2021 USEPA CCR RULE PERIODIC OPERATING RECORD RUN-ON AND RUN- OFF CONTROL PLAN REVIEW REPORT

LANDFILL

Coffeen Power Plant

INITIAL TO PERIODIC SURVEY COMPARISON CCR LANDFILL COFFEEN POWER PLANT COFFEEN, ILLINOIS		
		DRAWING 1
GLP8027.02	MAY 2021

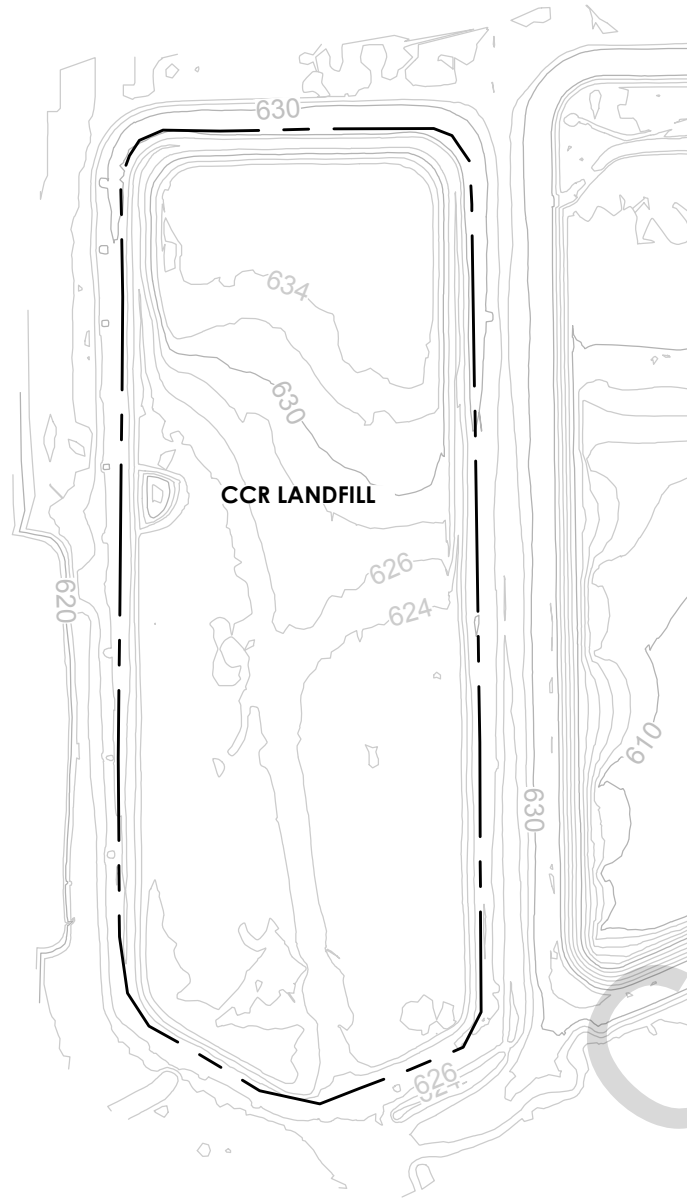
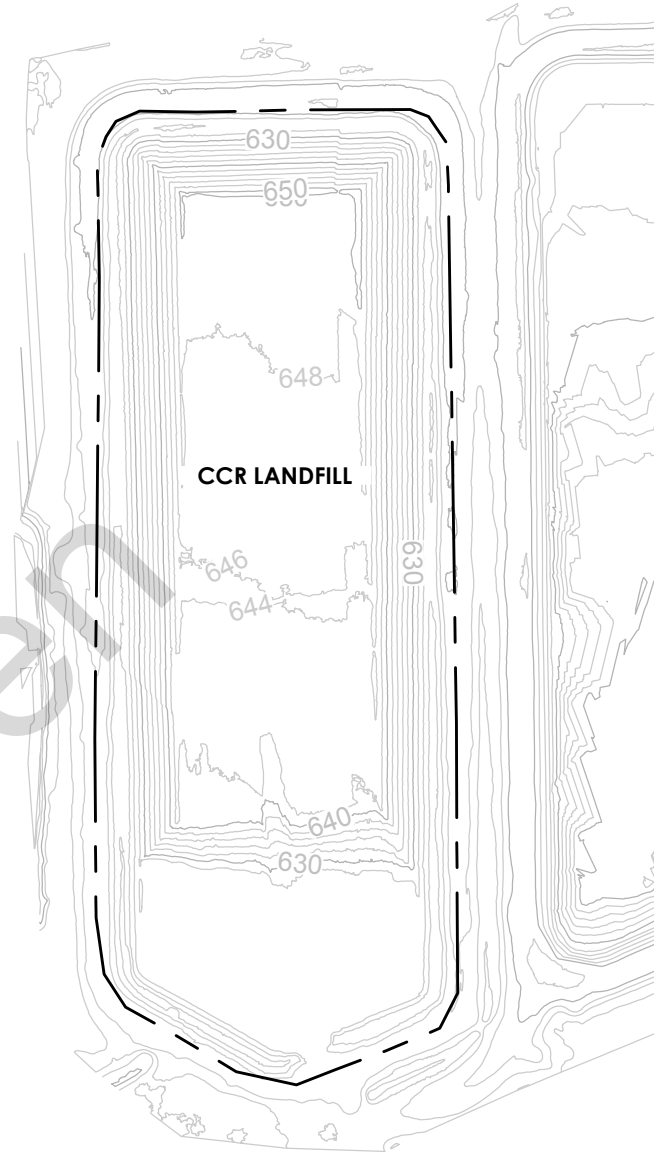
The comparison indicated that approximately 289,000 CY of CCR was placed in the LF between the 2015 and 2021 surveys. The comparison also indicated a slightly reduction in elevations of the perimeter berms and channels, however this may be due to differences in survey equipment and/or vegetation height at the time of the surveys, as no changes occurred based on the annual inspection reports ([4], [5], [6], [7], [8], [9]). The comparison did not indicate that CCR had been placed outside the design grades of the LF.
